Engineer of Record for the Structure  
Structural Systems of N. Fl. Inc.  
Derek Bergener, PE 58552  
1634 SE 47th Street #3  
Cape Coral, FL 33904

This document has been reviewed for  
conformance with the design intent of the  
structure and specified design criteria.

SCALE: 1/4"=1'-0" DATE: 01/20/22 REVISED BY: BRAWN BY: KCD  
JOB ADDRESS: SOLUNA 6 UNIT  
CUSTOMER: D.R. HORTON JOB #: DRSOLU6  
1 OF 1

SOLUNA  
TOWNHOMES  
GCD# 14150

LOWER ROOF

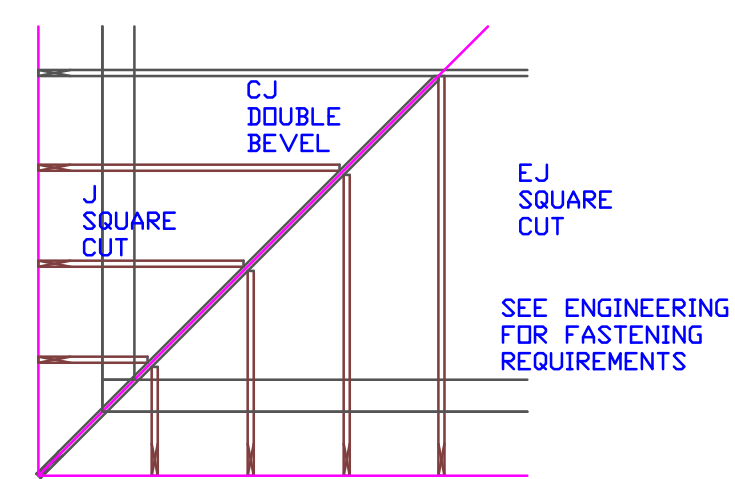
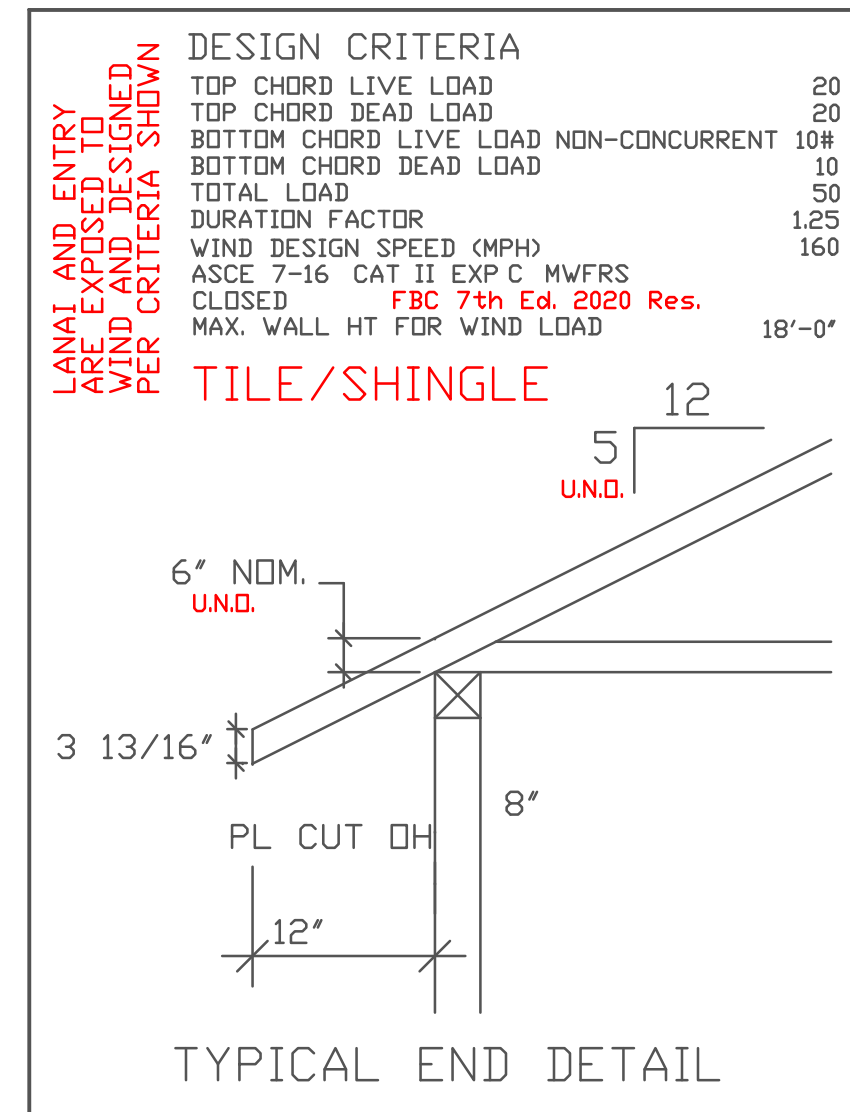
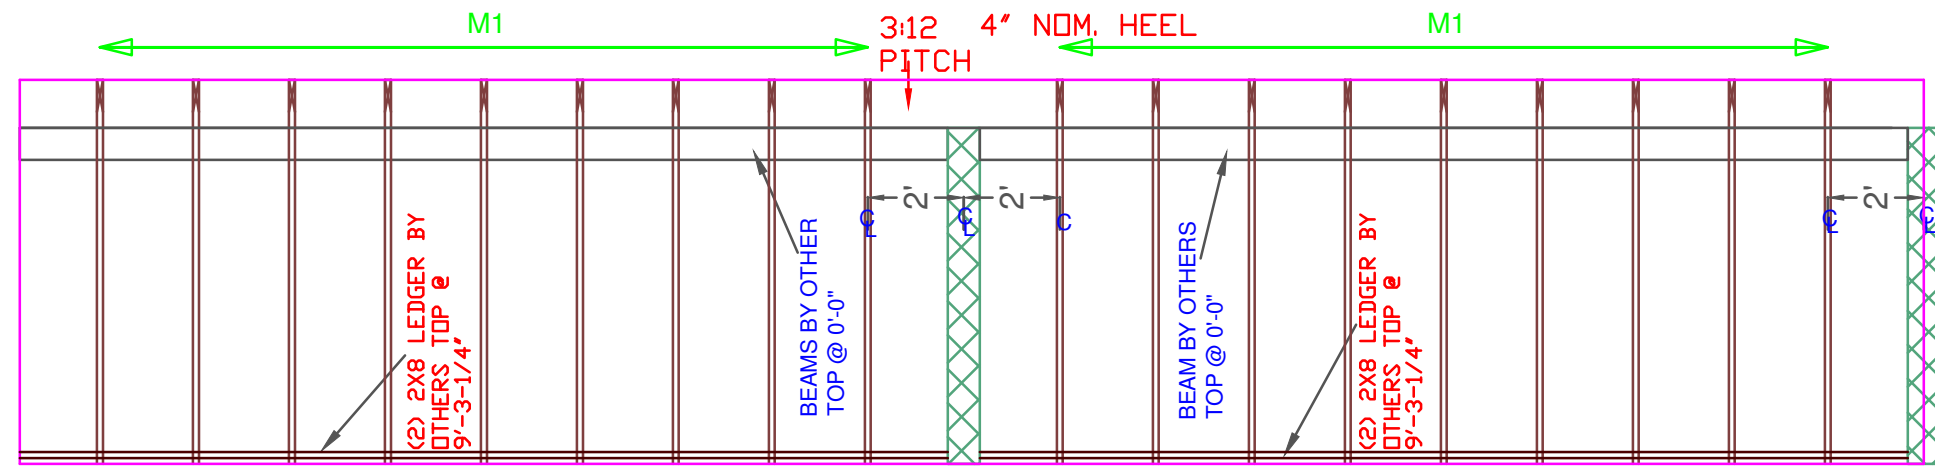
☒ Accepted As-Is ☐ Accepted As Noted ☐ Revise and Resubmit

SCOSTA CORP.			
WOOD, STEEL OR TIMBER ROOF & FLOOR TRUSSES			
3670 COMMERCIAL CENTER DRIVE SEBRING, FL 33870 (863) 385-8242			
SCALE: 1/4"=1'-0"	DATE: 01/20/22	REVISED BY:	DRAWN BY: KCD
JOB ADDRESS: SOLUNA 6 UNIT FLRS		1 OF 1	
CUSTOMER: D.R. HORTON		JOB # DRSOLU6

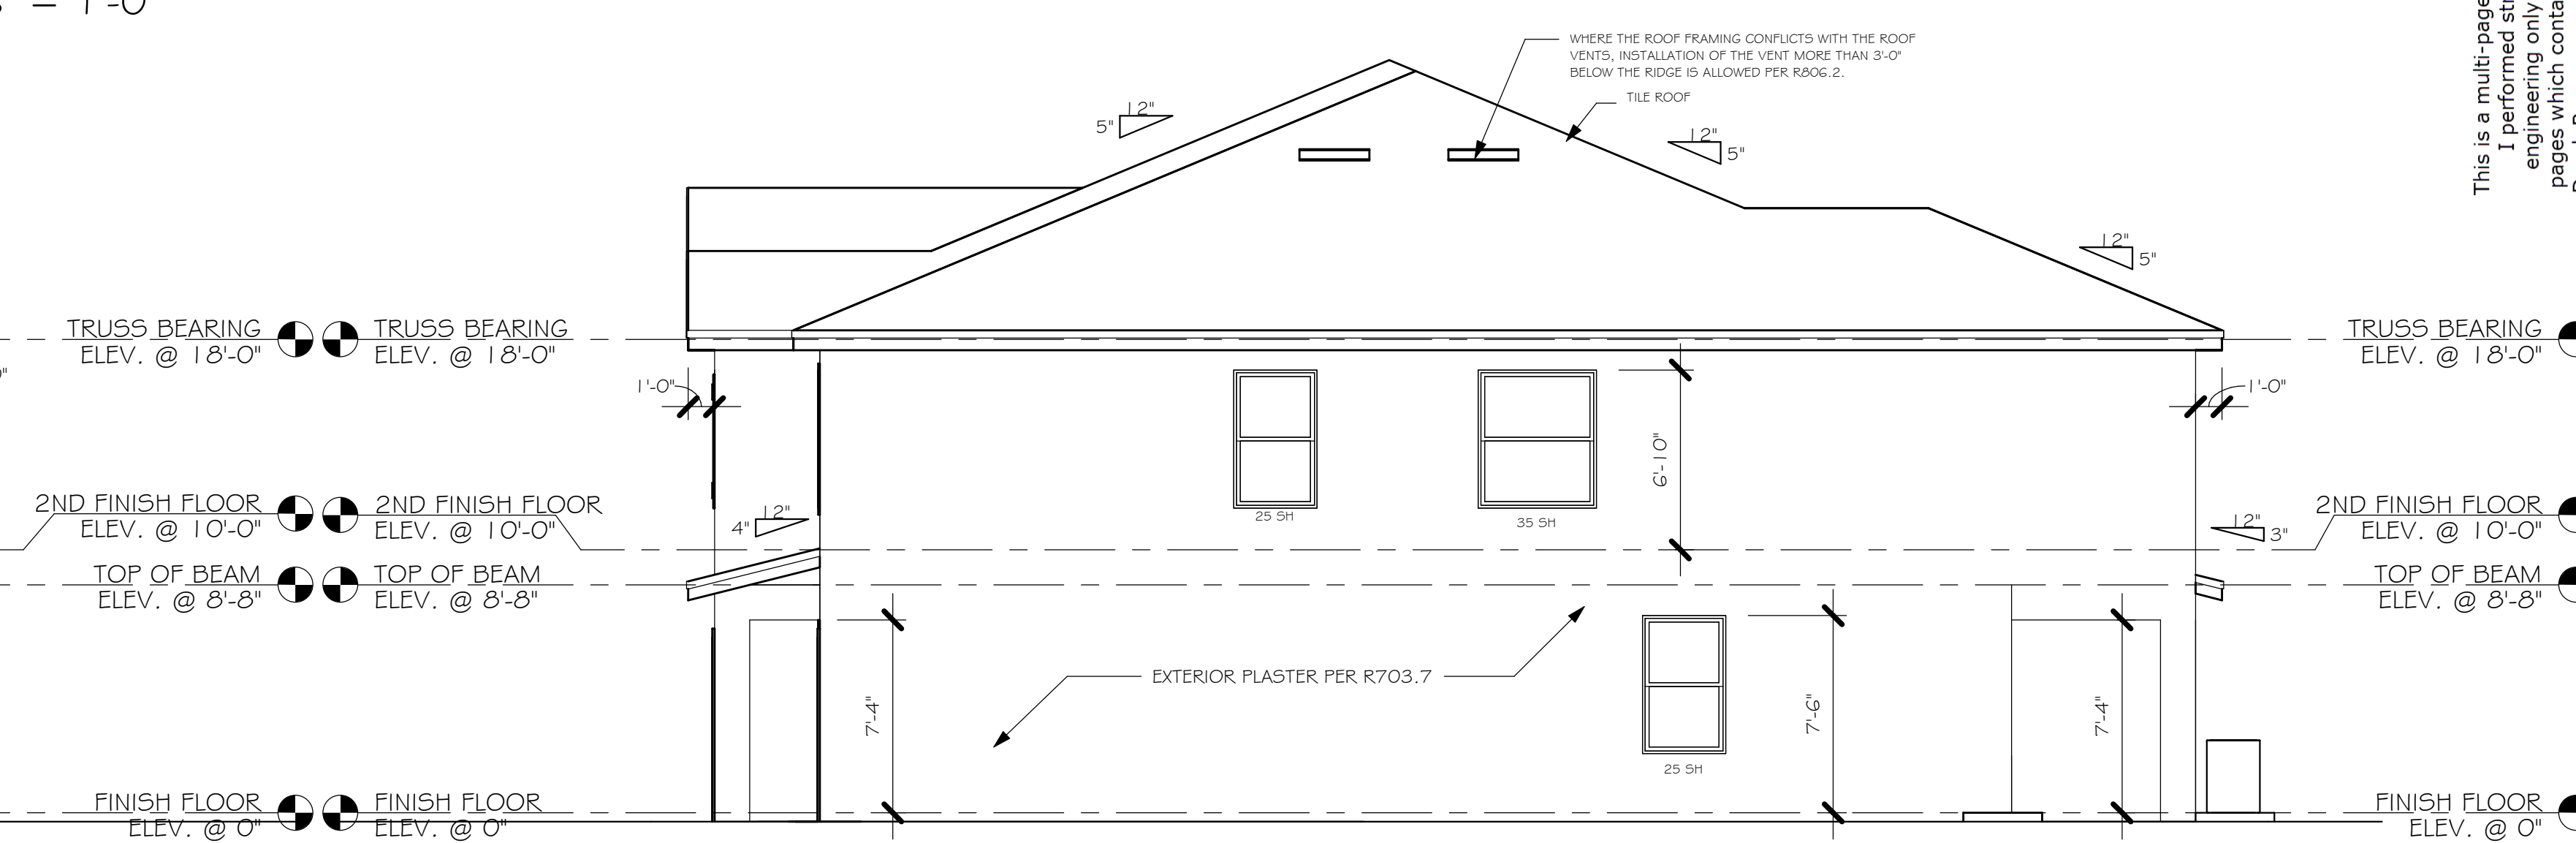
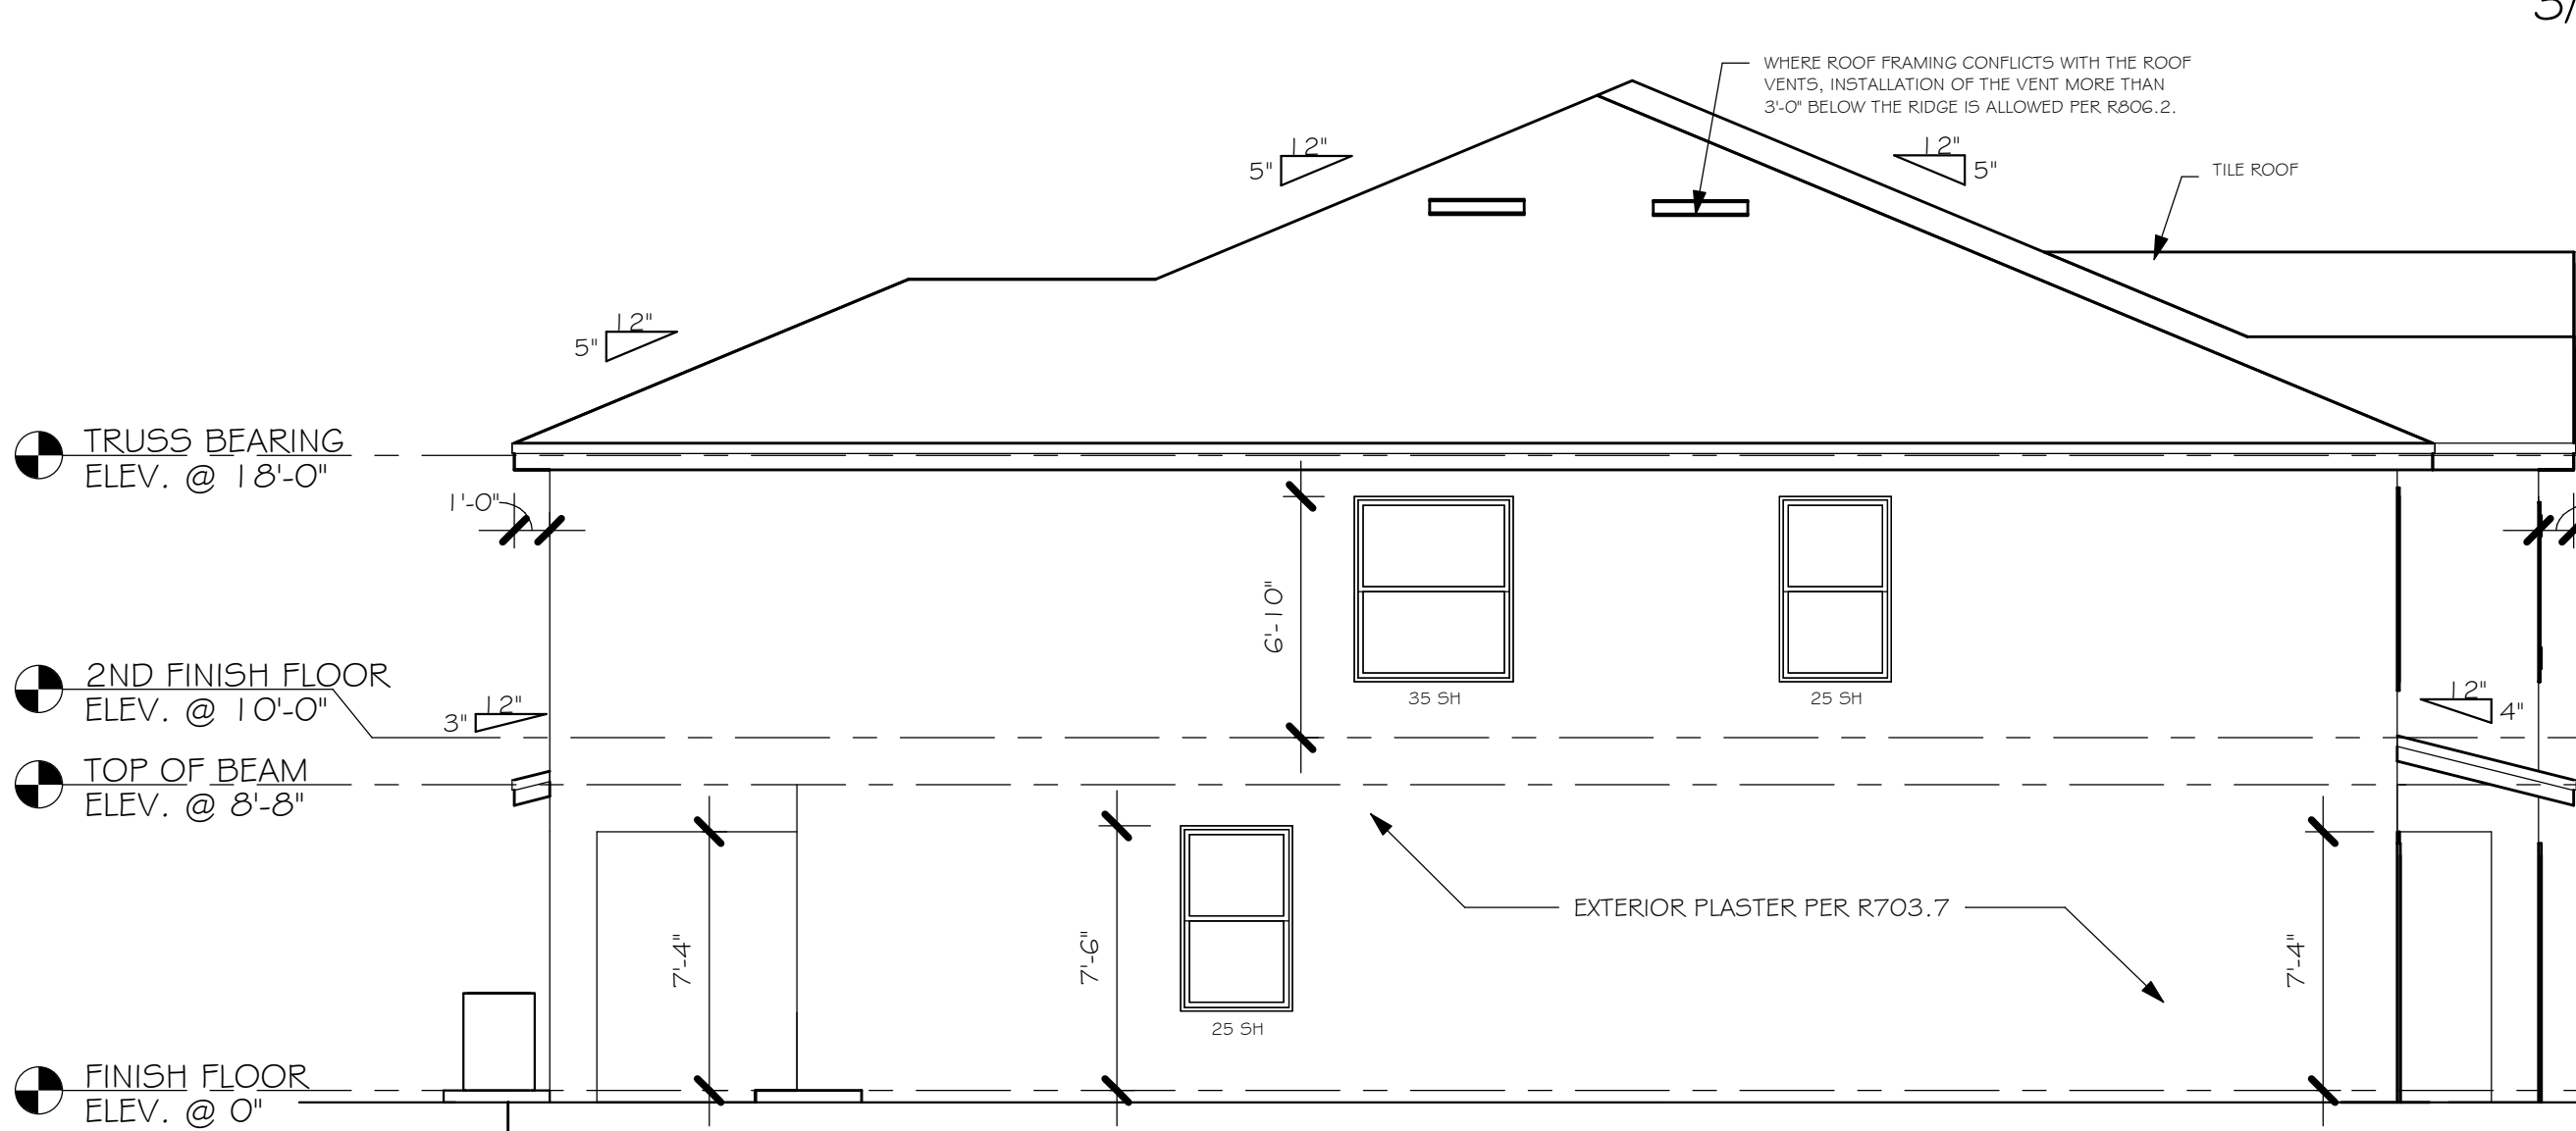
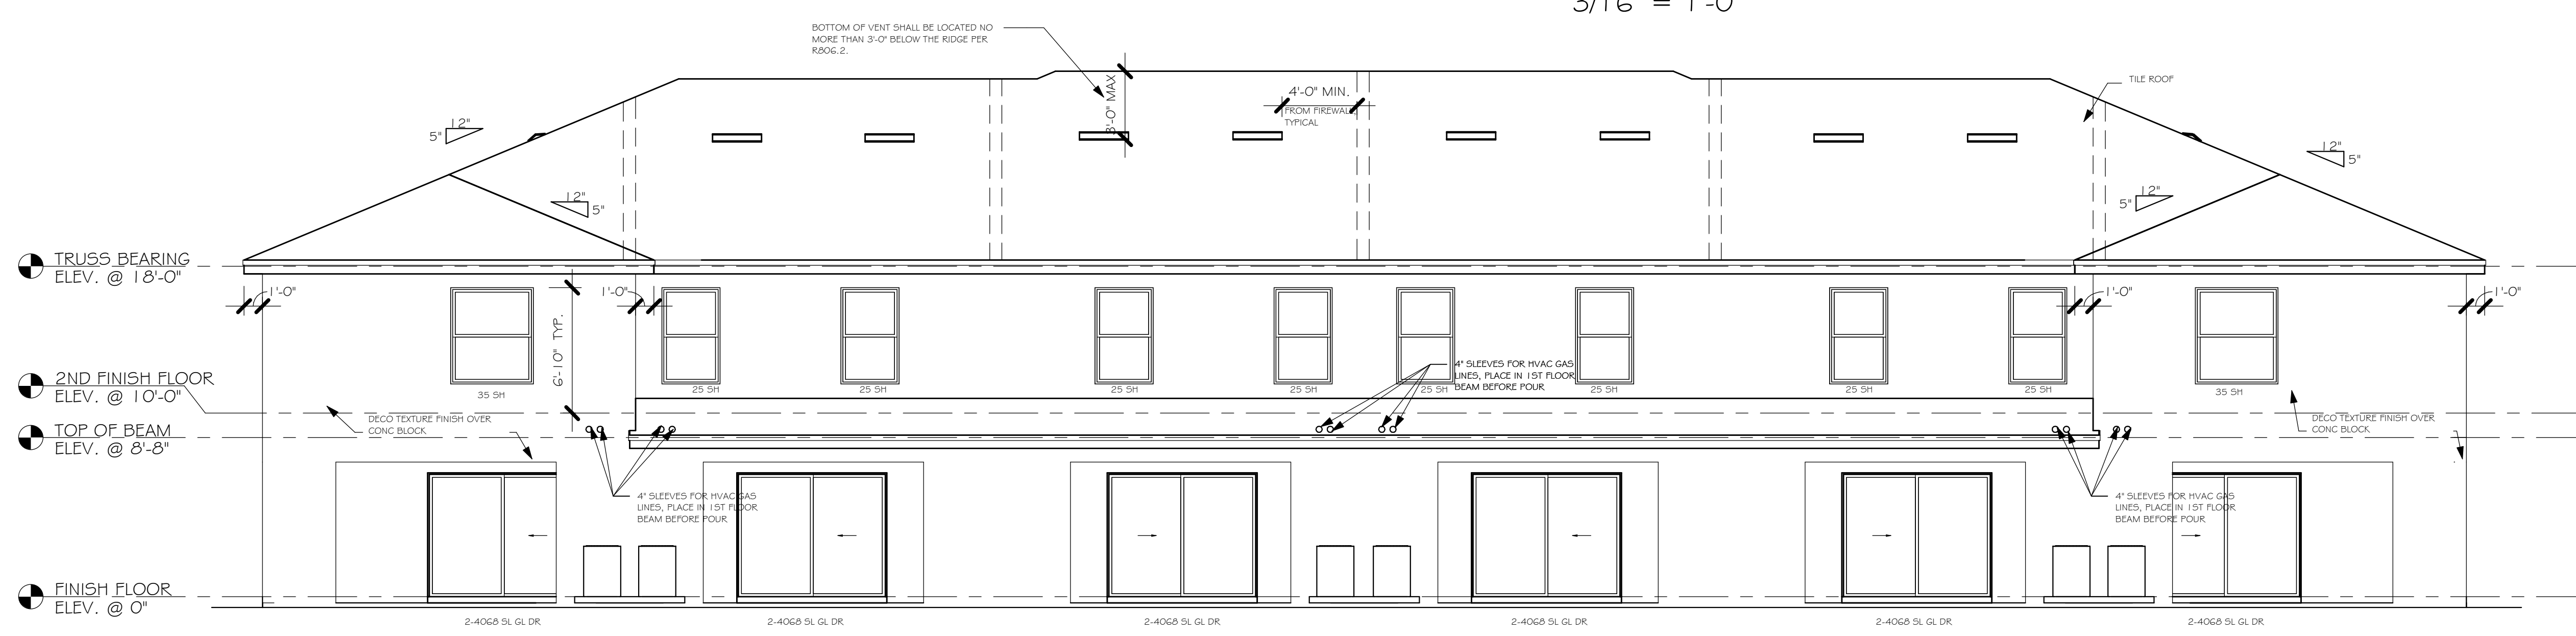
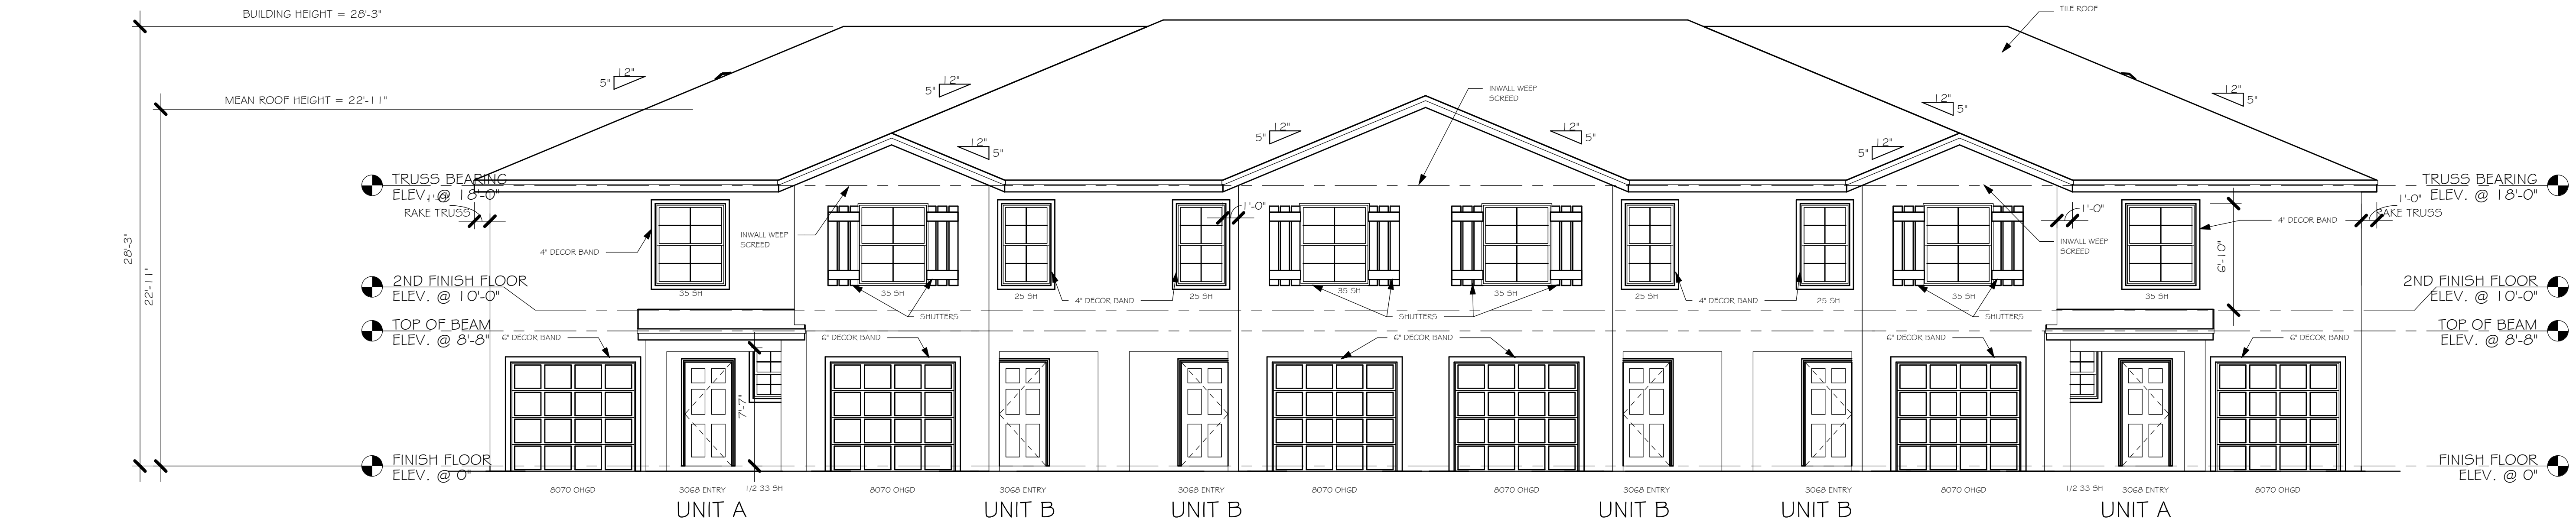
This document has been reviewed for conformance with the design intent of the structure and specified design criteria.

☒ Accepted As-Is      ☐ Accepted As Noted      ☐ Revise and Resubmit
